## **Addendum # 1 Recreation Center Storage Addition**

Date of Addendum: 5/25/2023

## Revised Drawings – Becker Morgan

**3 WALL SECTION**  
SCALE: 3/4" = 1'-0"

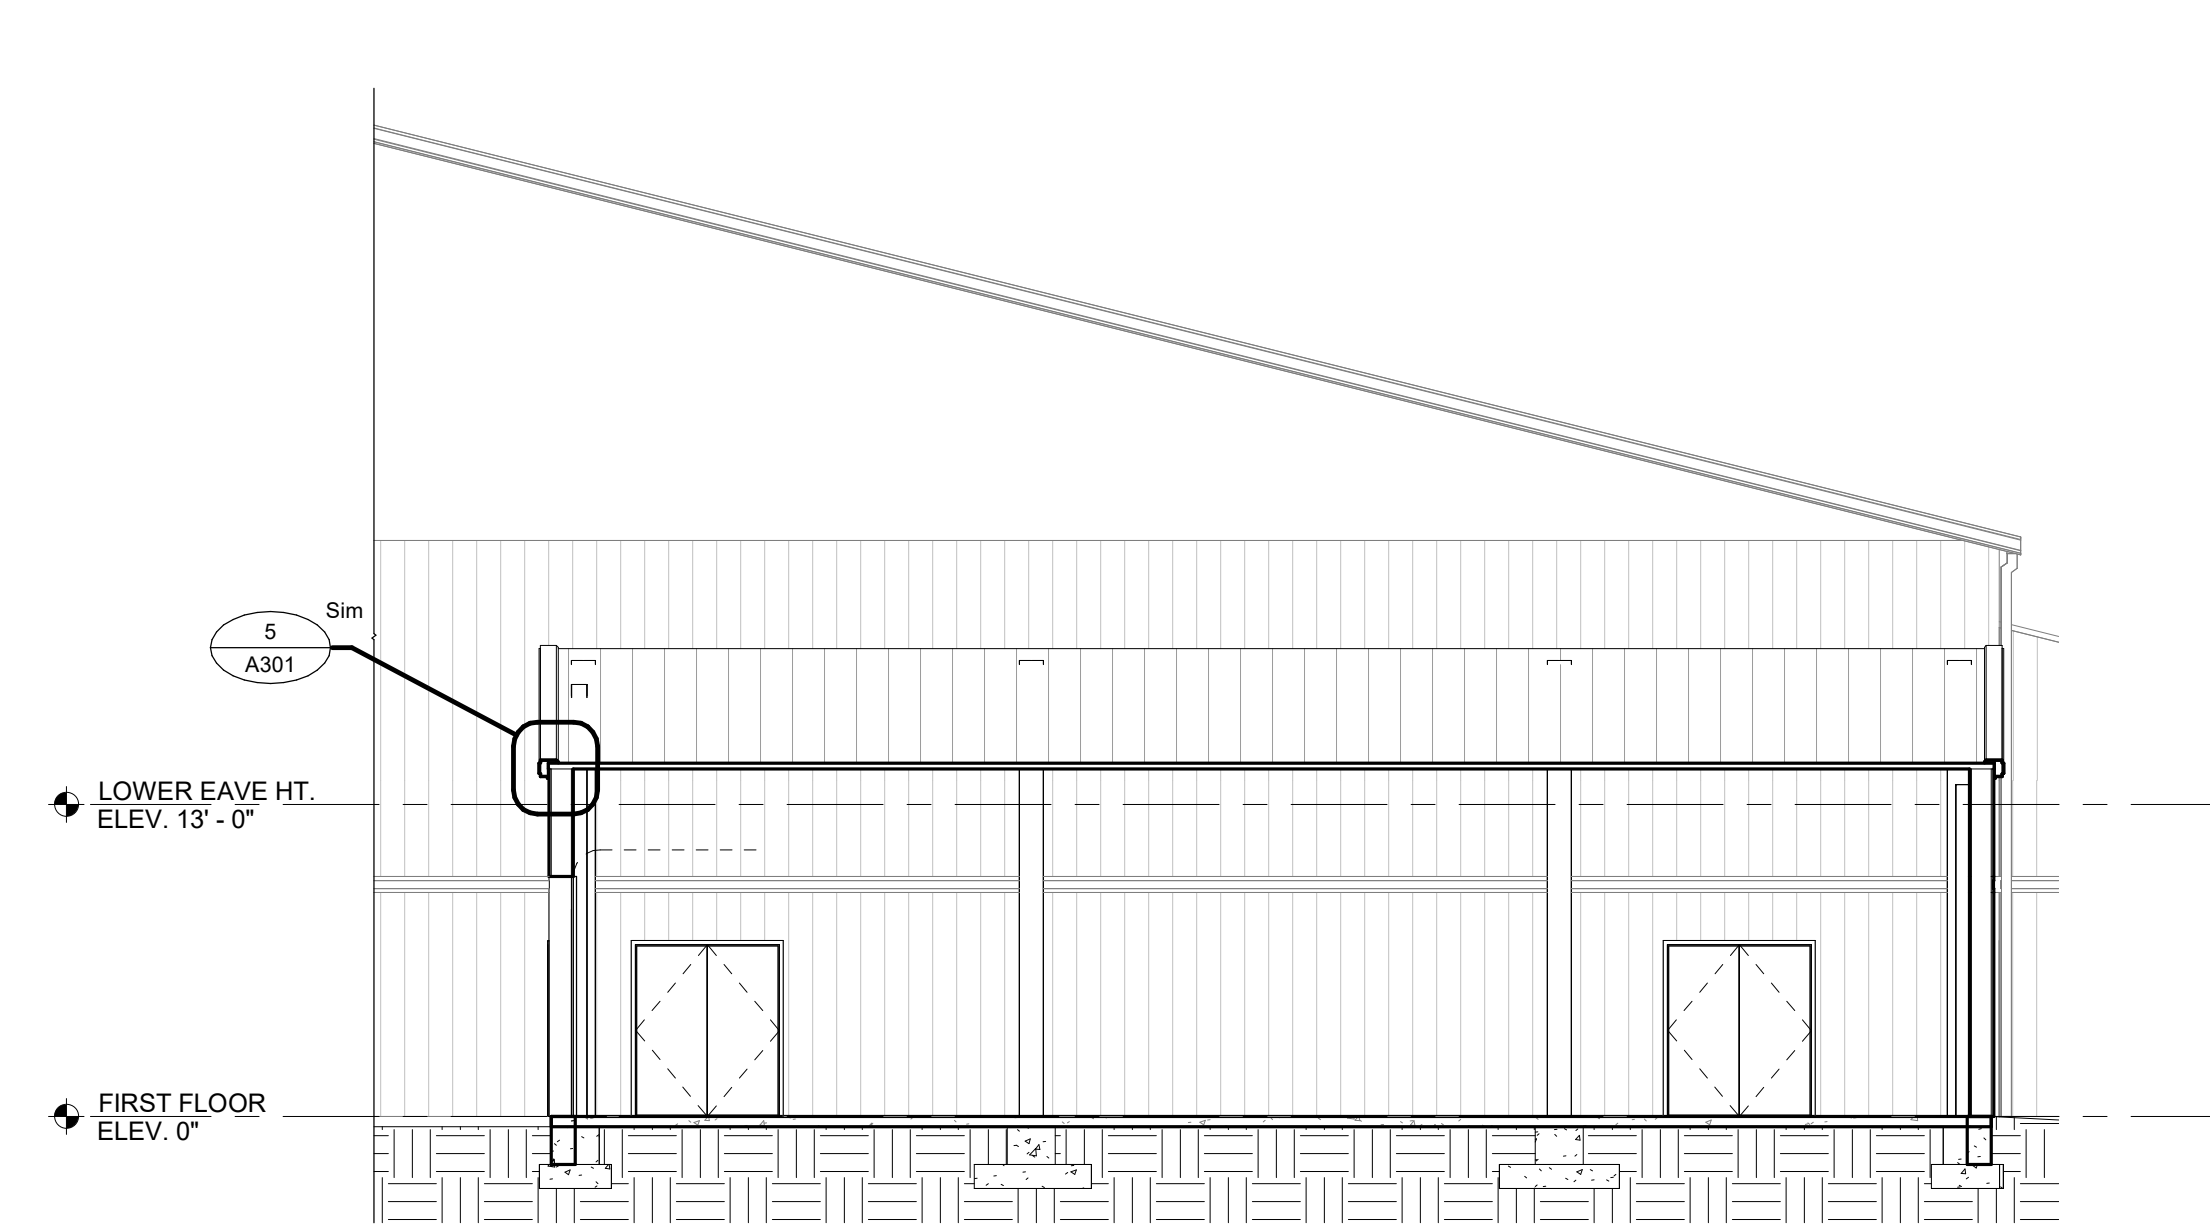
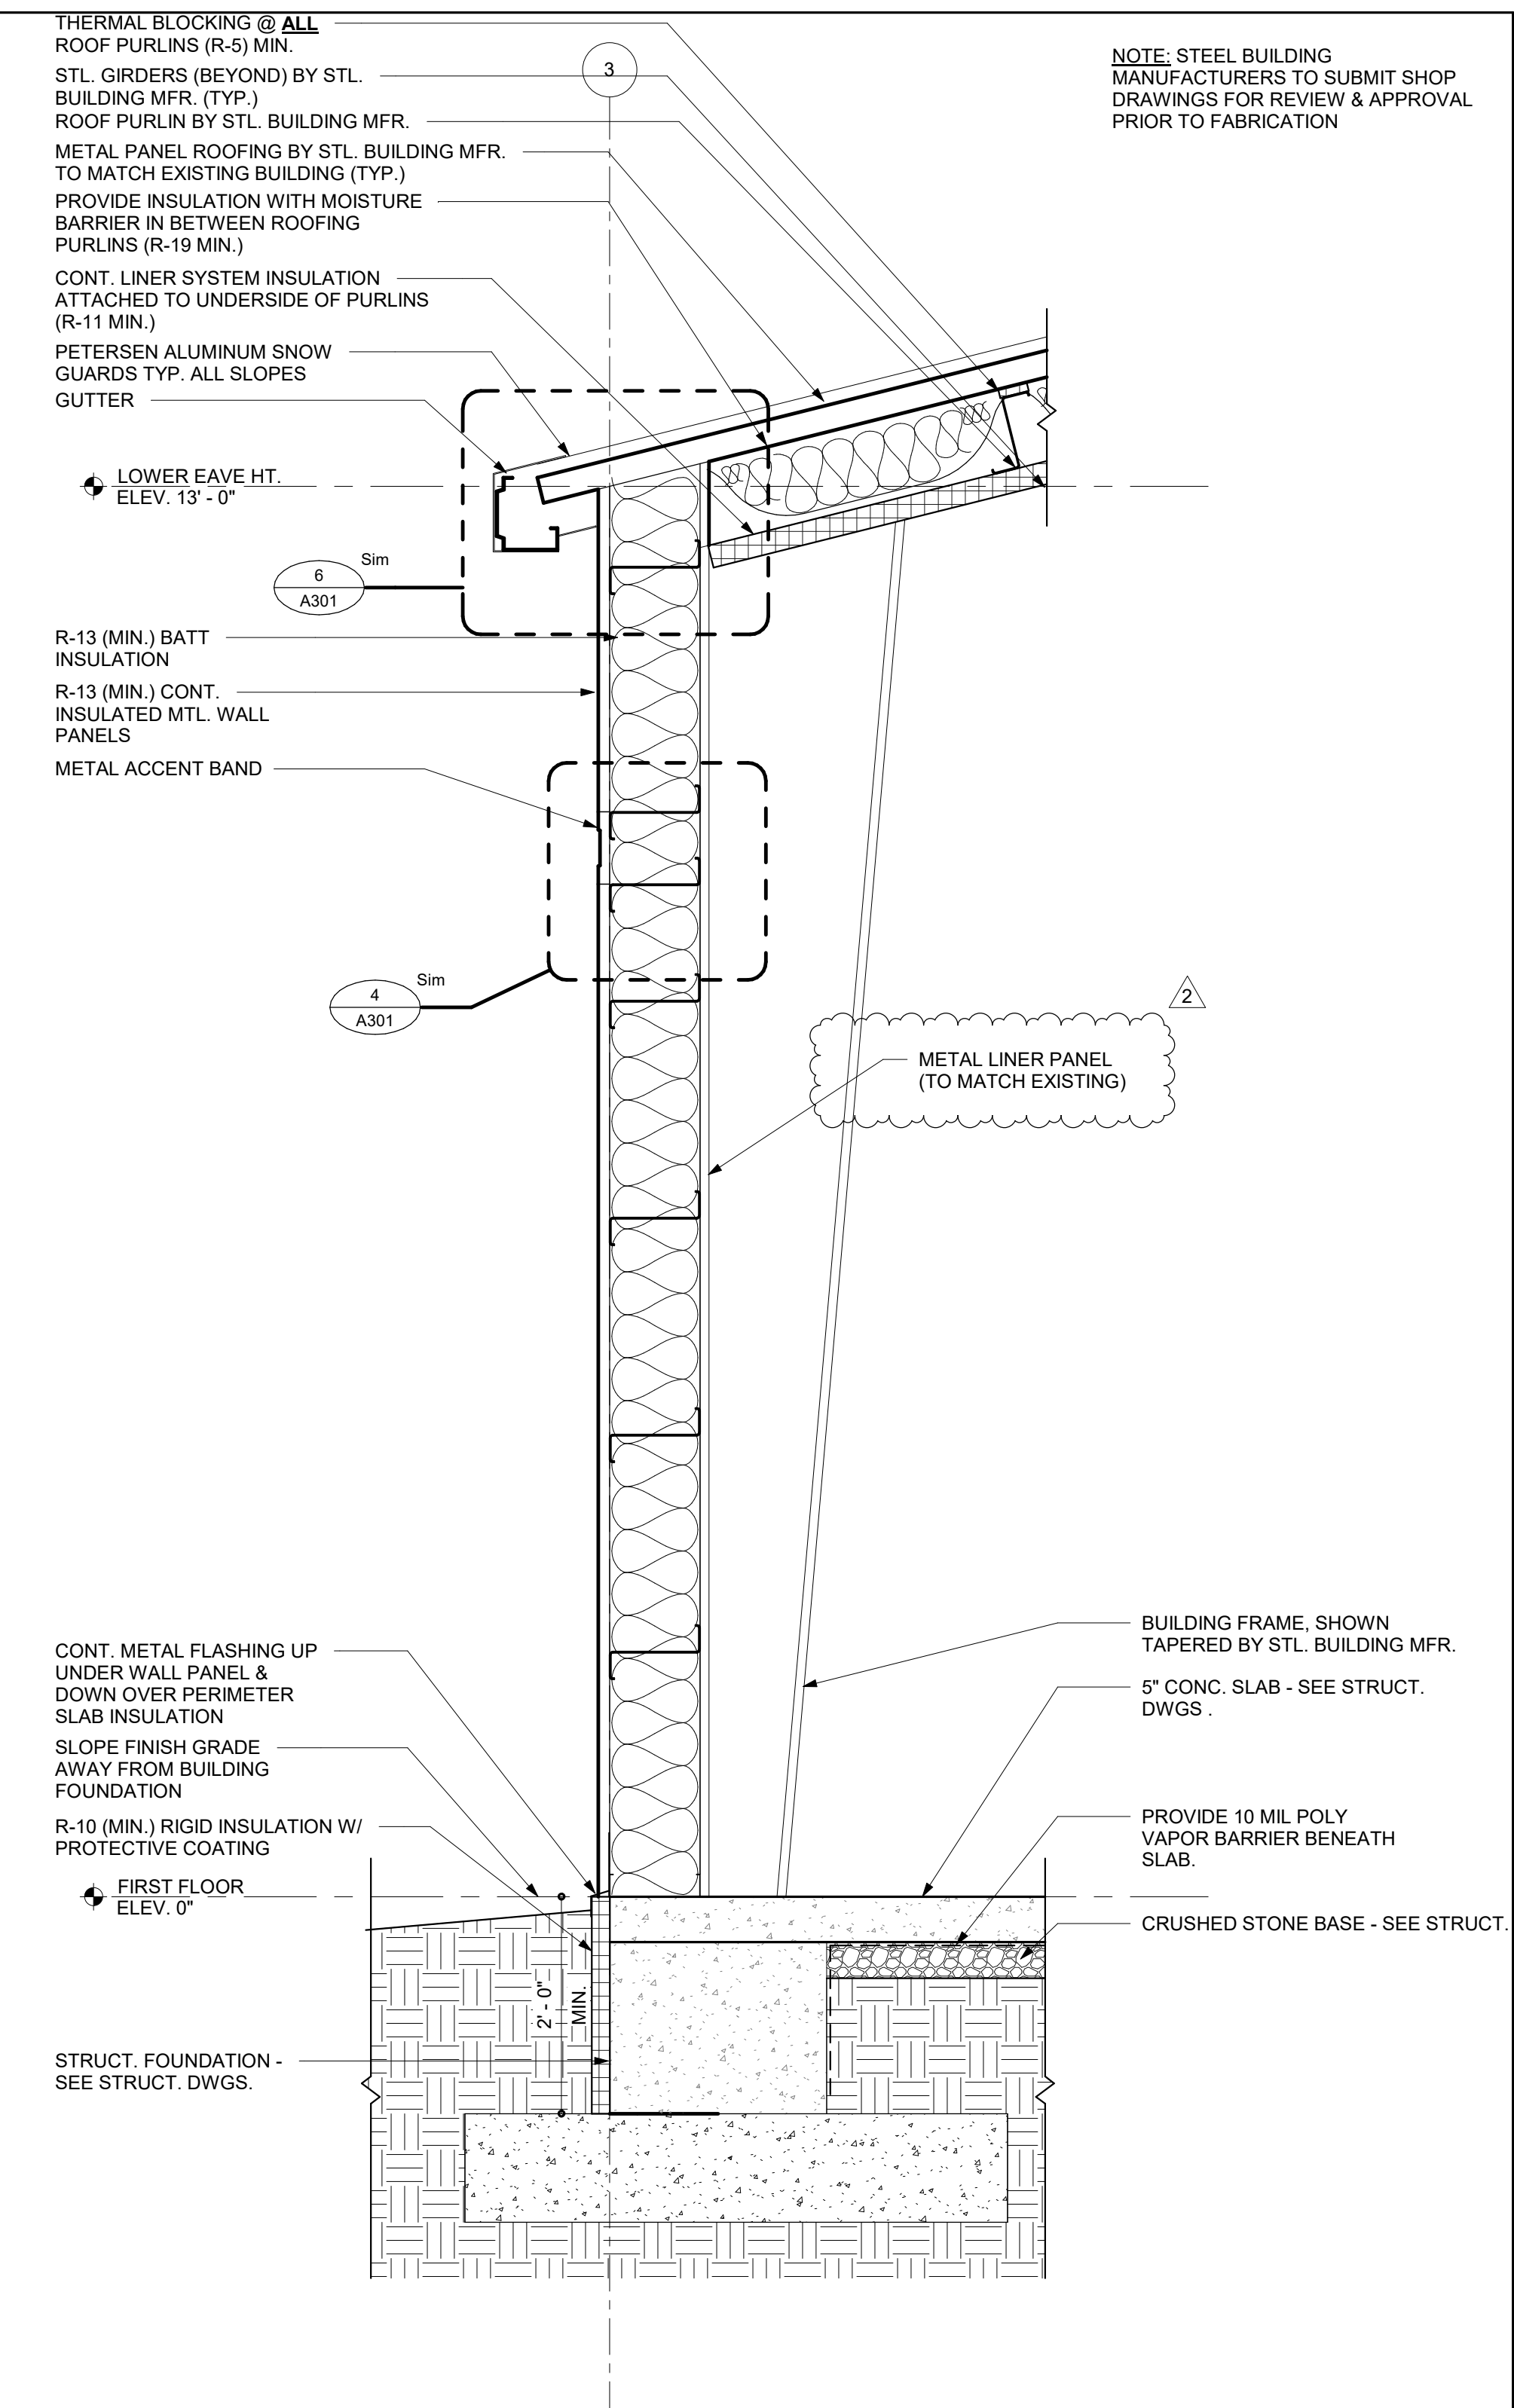
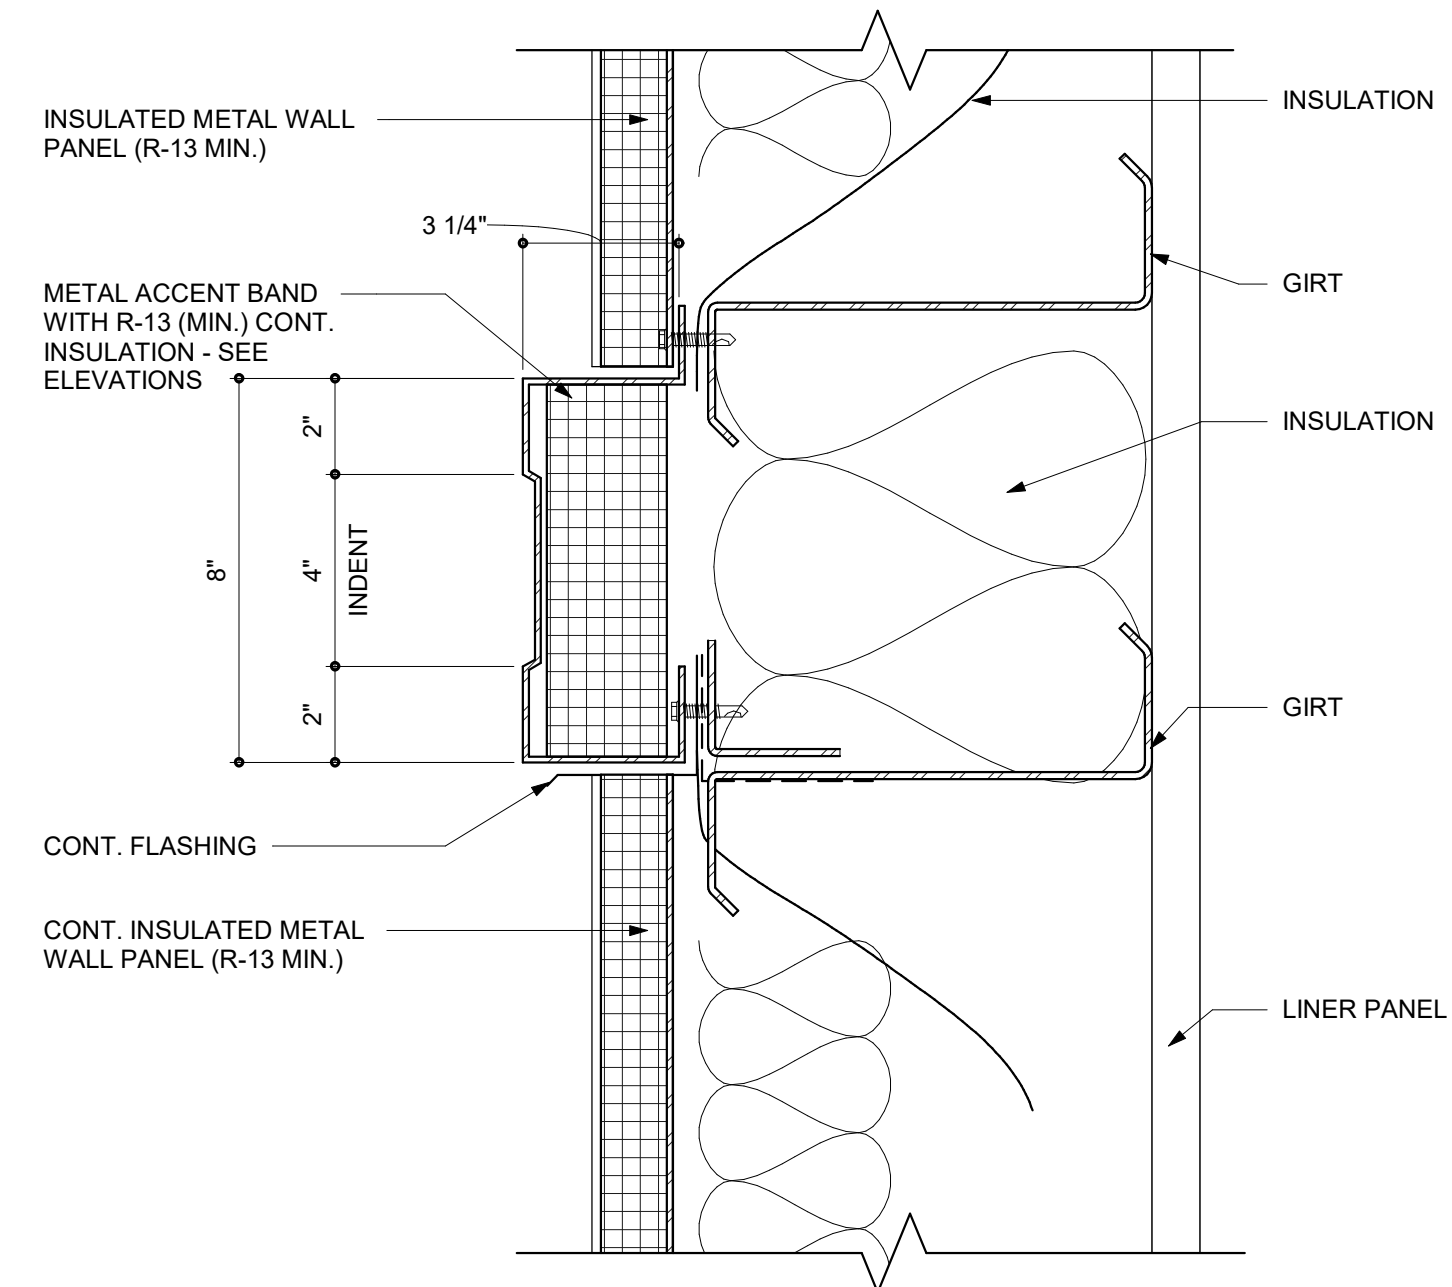
- 5) Drawing Sheet S001 – Wind load design data changed from 120mph to 124 mph.
- 6) Drawing Sheet A301 – Detail 3 revised to show continuous R-10 exterior insulation at exterior face of slab/foundation in lieu of insulation below the slab to comply with IECC.
